NOTICE OF SHORELINE TASK FORCE REGULAR MEETING
CITY OF SOUTH PADRE ISLAND

ITEM
Discussion and action to provide a recommendation to City Council regarding a beach and dune permit at 5820 Gulf Boulevard. (Kornblum)

MEMORANDUM: PRELIMINARY DETERMINATION

Beachfront Construction Certificate and Dune Protection Permit in the City of South Padre Island
Site Address: 5820 Gulf Blvd, South Padre Island
Legal Description: So Padre Is- Fiesta Isles Lot 6 Blk 191
Lot Applicant: Robert Moya c/o Alfredo Silva Jr.
GLO ID No.: BDSPI-26-0151

5912C
5912B
5916
9920
Beach Access #
23 Sapphire
Gulf Blvd
Gulf Blvd
Gulf
5903
5901

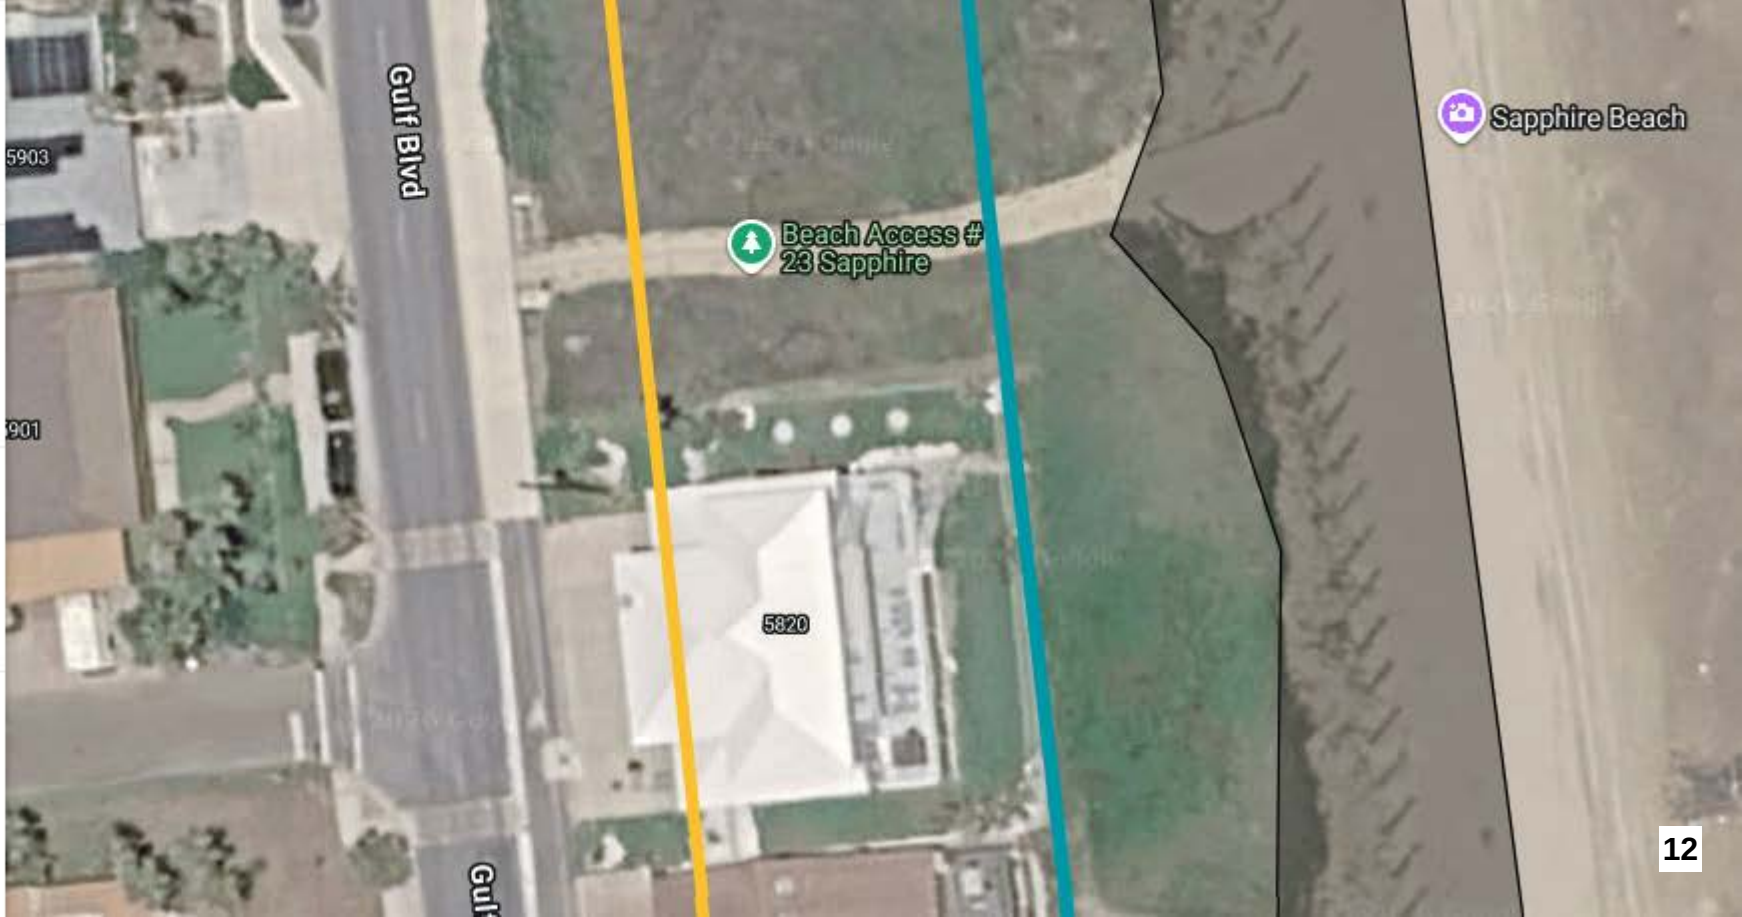
Because the proposed property and walkover are located within 100 feet of a public beach access point (as indicated on page 5 of the application), the project conflicts with the proposed special provisions of the City's *Dune Protection, Beach Renourishment, and Beach Access Plan*. These provisions that have been put forth regulate new access paths and dune walkovers within a 100-foot buffer of any public access location to prevent unnecessary dune fragmentation and promote shared access routes.

City staff advised the applicant to avoid constructing an entirely separate pathway through the dunes by either using the existing public access or connecting a new path directly into it. Although informed of this recommendation, the applicant chose not to modify the design to integrate with the public access. Consequently, the proposed plan does not comply with the City's Beach Use and Access Plan.

Proposed Boardwalk Plan

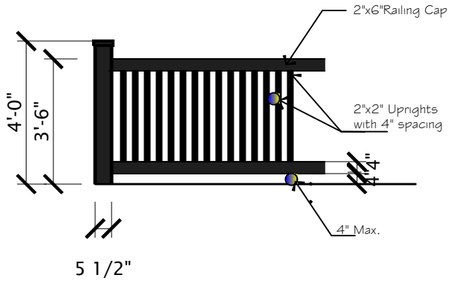
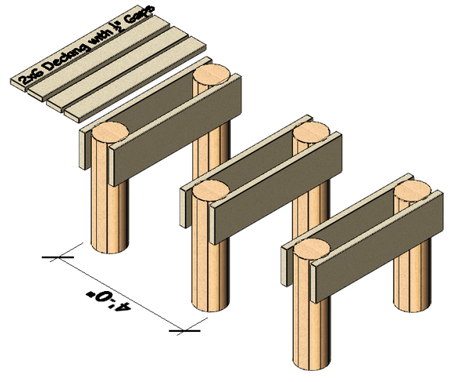
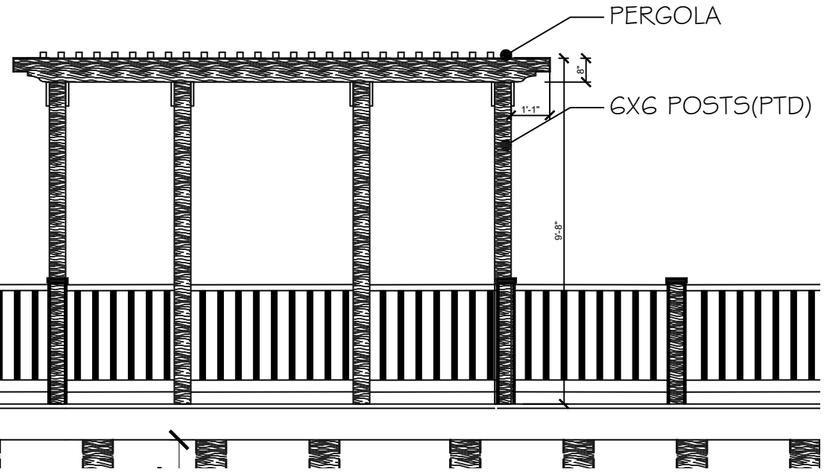
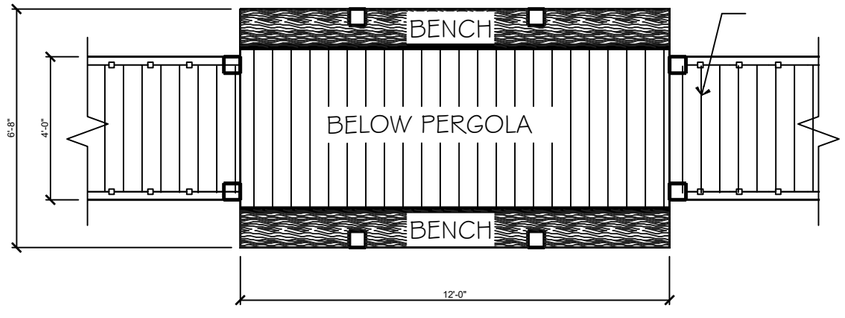
- The applicant proposes to construct a 4-foot-wide dune walkover with a 12-foot by 8-foot pergola structure, which does not comply with the width requirements for dune walkovers and similar structures in the Texas Administrative Code (TAC). 31 TAC 15.6(i)(1)(A) requires the width of a dune walkover or similar structure to be limited to 4 feet wide.[1] An increased width may be permitted for public access walkovers, shared walkovers for three or more residences, or wheelchair or golf-cart use with approval from the local government.[2]
    - The pergola does not meet the above exceptions for an increased width.
    - Before the City issues a permit, the applicant must submit revised plans to the City demonstrating that the dune walkover and pergola structure will be limited to 4 feet wide.

- The use of concrete to stabilize dune walkover pilings is prohibited.[6]
